# Appeal Application for City Council

Project Name: Venitownhouse

**816 Ormond Street, Venice Fl 34285 Parcel #0175-11-0225;**

**City Petition #25-45SP**

EXHIBIT 2  
①  
(1/8" = 1'-0")

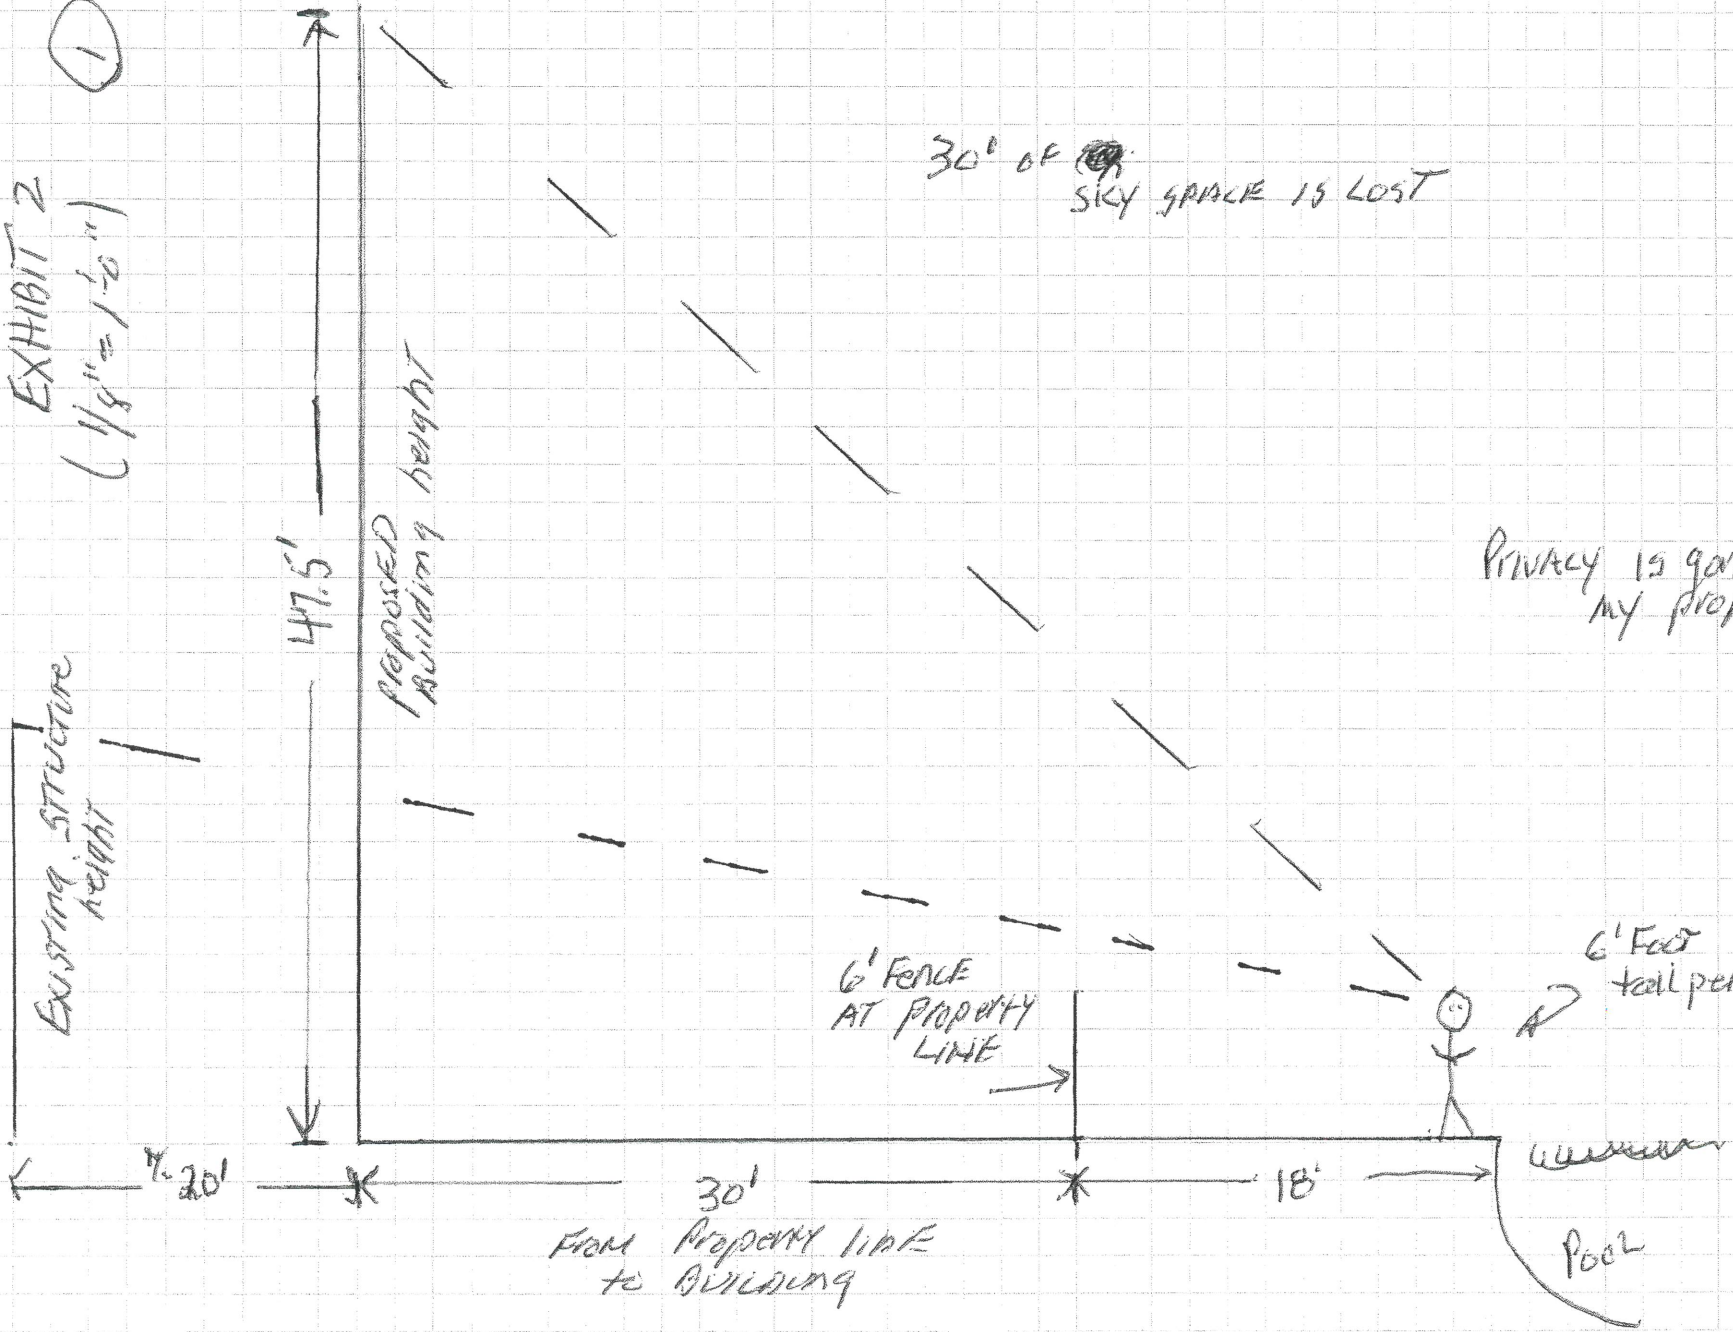
1. **Height.** The current proposed height of this six-unit structure has a roof height of 47.5 feet (Coastal Architecture drawing A2.00 date 11/24). Building heights on Ormond and Madrid have a maximum height of 30’ (1 structure) with many below 20’ but an average of 21 feet. This proposed building clearly dwarfs all surrounding structures inclusive of all properties on Madrid, Heigl, Ormond and Apalachicola. We as neighbors (**Exhibit #4 Petition**) feel this is unjustified and unacceptable in height based upon surrounding existing homes. Lowering the building “compatible” with the neighborhood still allows 6 units but respects other neighbors and respects privacy. **We look to the Council for this amendment to documents.**

30' OF ~~THE~~ SICKY SPACE IS LOST

PRIVACY IS GONE ON MY PROPERTY

**Photo - 9** view of property looking east  
816 Ormond Stre

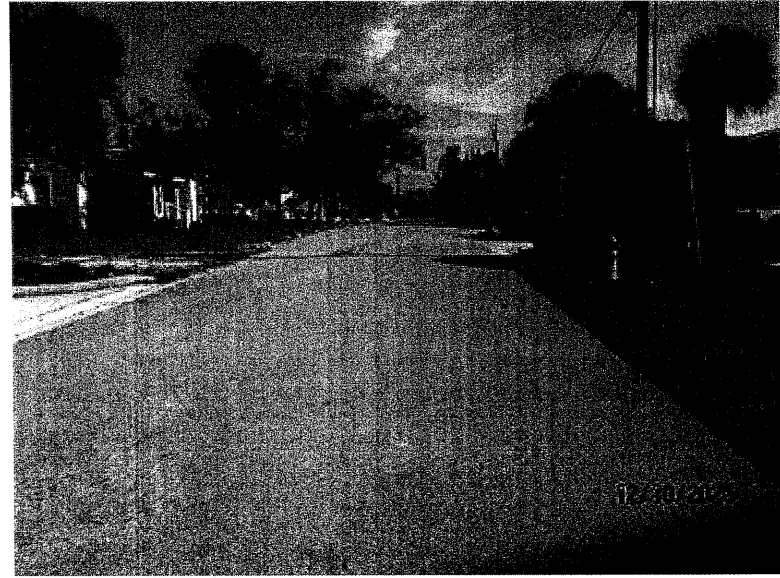
proposed building structure. The palm tree canopy that now lines the north side of Ormond Street will be removed. Please refer to the attached pictures(**Exhibit 3**) as to what the tree canopy looks like today from the third floor level of Che Vista and from the street elevation. When reviewing the new landscape plan it appears to be minimal with little to no greenscape to hide the building mass from neighboring properties with emphasis to the north. They discuss how the landscaping plan is over an above the requirements but this landscape plan in no way provides a buffer to attempt to soften the building structure as they are 3-gallon in size or 1.5" caliper 6' high trees.
